MEMORANDUM TO: File

FROM: Warren C. Lyon, Senior Reactor Engineer  
Reactor Systems Branch  
Division of Safety Systems

SUBJECT: ASSESSMENT OF THE WESTINGHOUSE / ADVANCE  
MEASUREMENT AND ANALYSIS GROUP (W/AMAG) CROSSFLOW  
ULTRASONIC FLOWMETER (UFM)

Figure 8. Normal Distribution

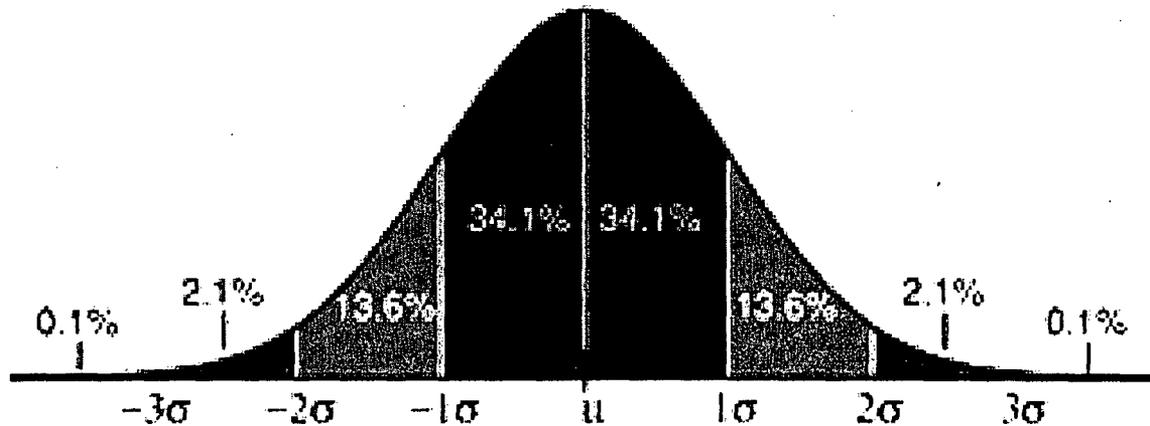
where  $\mu$  is the mean value and  $\sigma$  is the standard deviation. One expects that 68.2 percent of the time, a data point will fall within  $1\sigma$  of the mean and 95.4 percent of the time, it will fall within  $2\sigma$  of the mean. (Uncertainty, as used by the organizations of interest here, is represented by the 95 percent bound which is approximately the same as  $2\sigma$ .) To conclude that data have converged on the basis of one or a few samples being within the  $2\sigma$  limit because the data scatter means one cannot do better is illogical. It fails to recognize that the expected value is the mean value, that the mean of a large number of samples will approach the true mean value, and, if the samples exhibit a trend, then sampling must be continued until convergence toward a mean is reasonably assured. W/AMAG and licensees appear to meet these principles when determining mean CROSSFLOW-indicated flow rate in power plants, but do not meet them when making decisions regarding test data applicable to such effects as determination of distance necessary downstream of an elbow so that the elbow no longer affects CROSSFLOW.

Figure 9. Overlapping Distributions

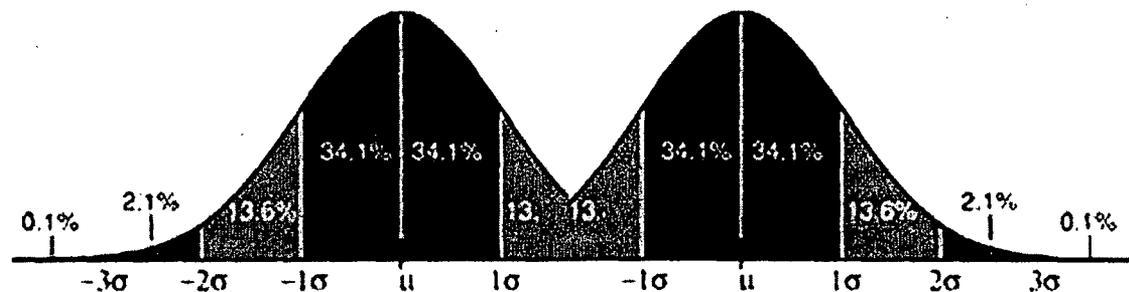
The area to the right of the mean is 0.5. The area to the right to the point of overlap in the left variable is  $0.341 + 0.130 = 0.471$ , and the overlapped area is  $0.5 - 0.471 = 0.029$ . Data selected at random for the left variable will overlap data for the right variable 2.9 percent of the time and the same is true for overlap of the left variable by data from the right. Stated differently, the probability that a datum from the left will overlap the right distribution at the same time as a datum from the right overlaps the left distribution is  $0.029 \times 0.029 = 0.00084$ , an unlikely occurrence. Yet this is the rationale that was applied to Byron when CROSSFLOW indicated one flow rate and other parameters indicated a different flow rate when the licensee concluded that the data were in agreement when the uncertainty bounds overlapped.<sup>13</sup>

Figure 24. Venturi Fouling During Startup (from Reference 42)

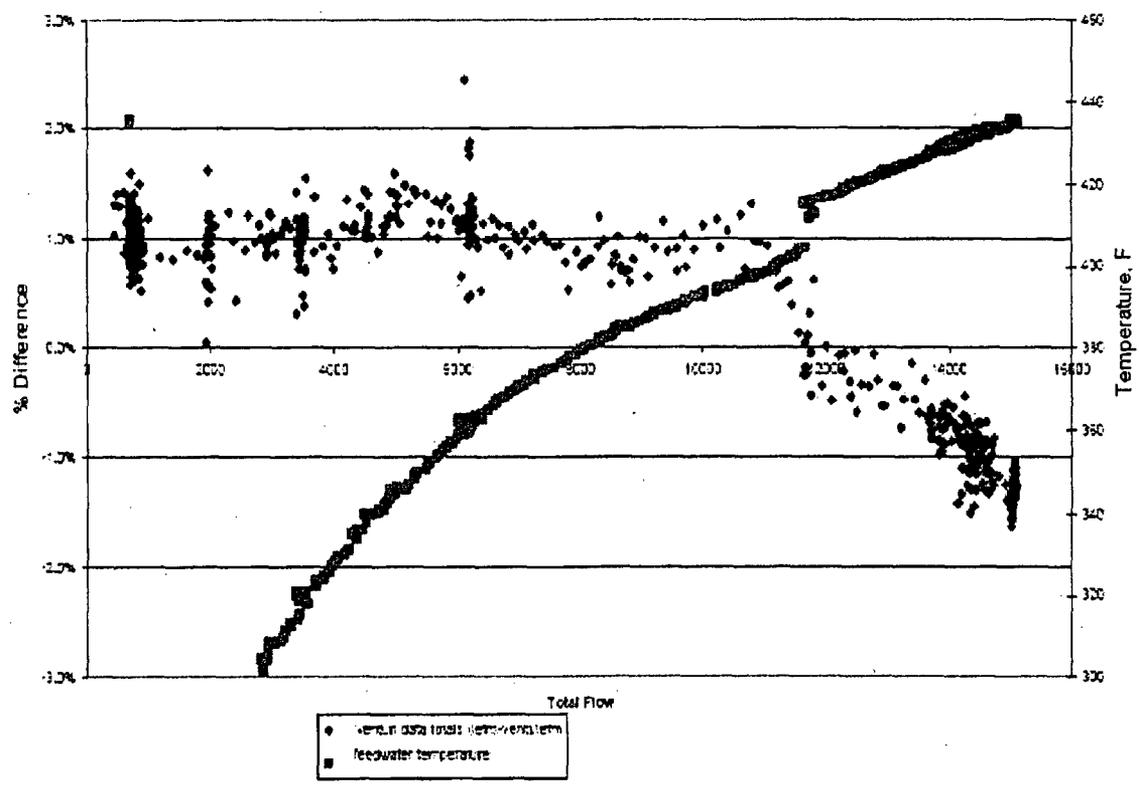
However, it is not sufficient to assume a venturi is unfouled just because it was recently calibrated. This is illustrated in Figure 24 which shows an example of venturi fouling at Millstone 3 in August 1998 before it could be returned to power following an outage. (The blue scattered data points are representative of the venturi fouling behavior that initiates at about 400°F. The lighter-colored pink points without significant scatter are feedwater temperature measurements and are an indication of power level.) Since the fouling occurred between about 400°F and full power at 437°F, it would be difficult to recognize this condition from evaluation of changes in other plant parameters. The NRC staff believes that this type of behavior must be reasonably established as not occurring in order to justify use of venturis for CROSSFLOW calibration.

Figure 27. Variation of Venturi C with Re

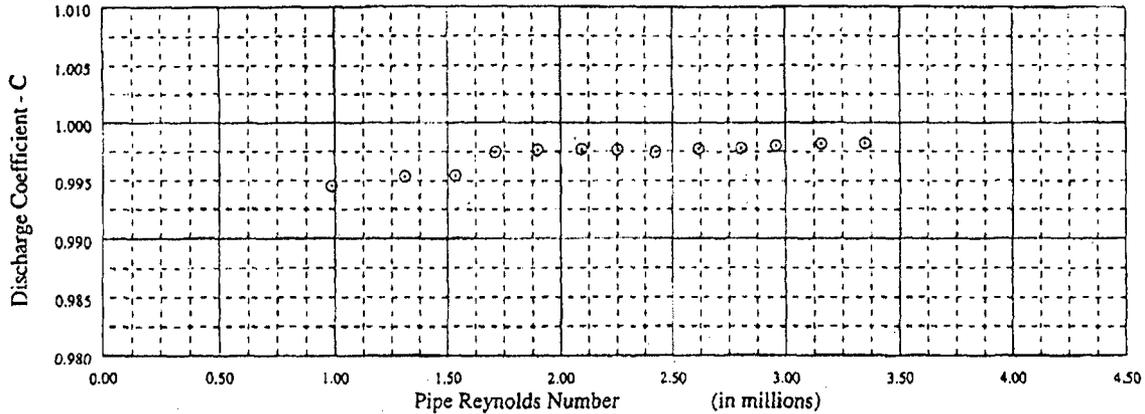
The reason for the first three C's at lower Re being lower than the other data points was not addressed. The NRC staff notes that this scatter was less pronounced in the data for the other venturi.

Figure 29. Comparison of PSU Theory and ASME Prediction

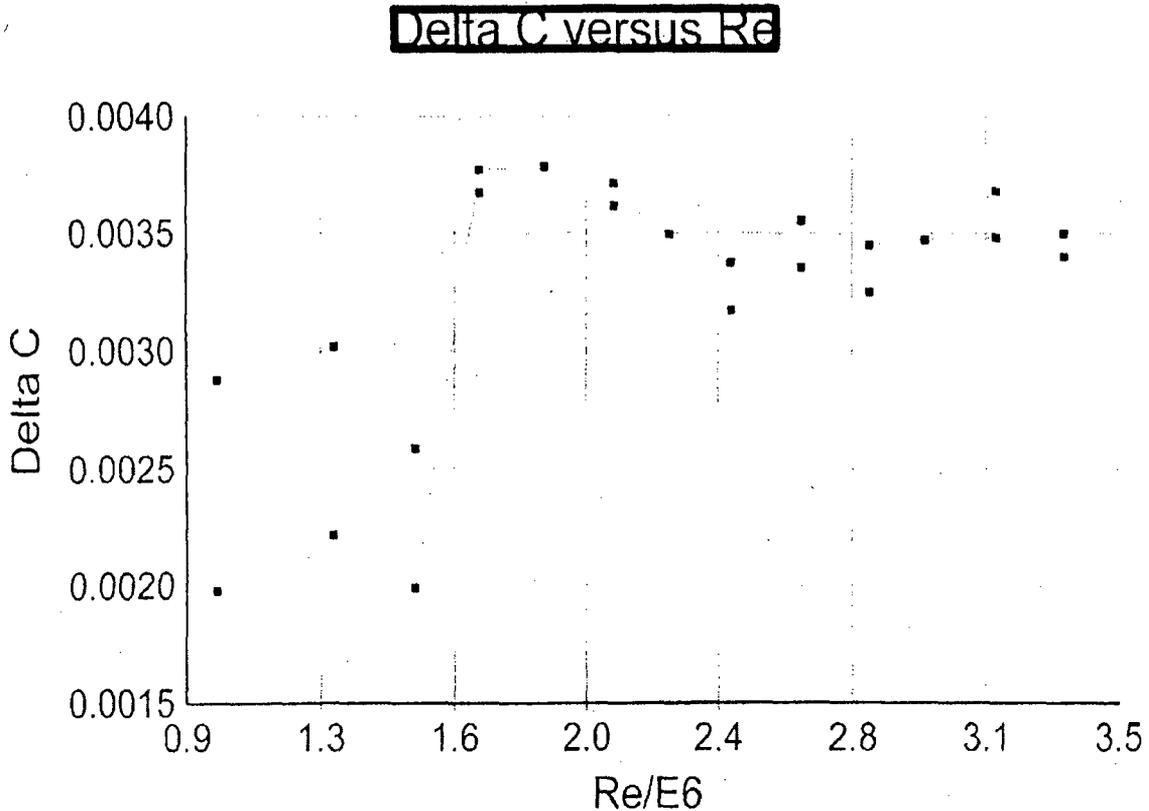
To better understand this behavior, the NRC staff generated Figure 29, which shows the difference between the coefficient calculated from data / theory and the ASME prediction. This shows the effect of the first three data points while the remainder of the data illustrate a higher average difference of about 0.0035. The increased scatter for the lower Re values may be in part due to the increased sensitivity of C with Re for smaller values of Re. The scatter appears to become smaller for Re greater than about  $2 \times 10^6$ . Reference 43 stated the average difference was 0.0032 and 0.0034 for the two data sets, a calculation based on all of the data. The latter values would be used for the Re extrapolation. The difference between the data and the ASME equation is about 0.33 percent. The actual extrapolation from the maximum test Re to a typical value for use in the plant, assuming the ASME equation behavior is representative, is a correction of about 0.14 percent. Reference 43 calculated the uncertainty associated with C to be 0.133 percent and stated that "the flow measurement uncertainty is better than 0.15%." The NRC staff has the following observations:

Figure 36. Calvert Cliffs Loops 21 and 22 Long Term Behavior

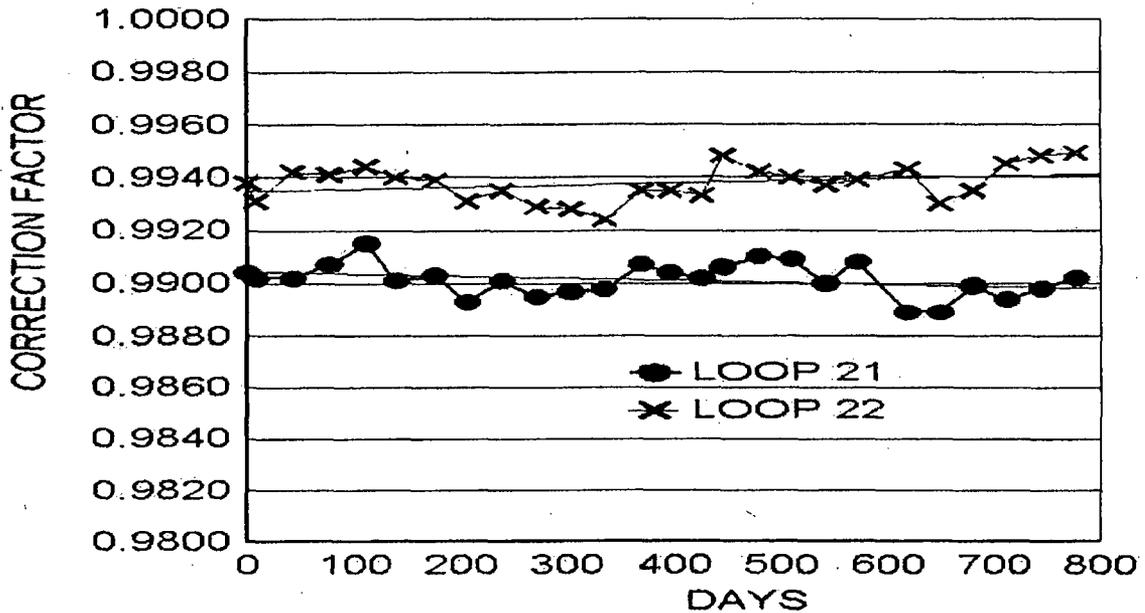
Figure 36. Over close to 800 days, loop 21 shows a slight upward trend of 0.05 percent and loop 22 has a slight downward trend of 0.06 percent. These data tend to support the Reference 18 conclusion that CROSSFLOW "is capable of maintaining a precise calibration," although
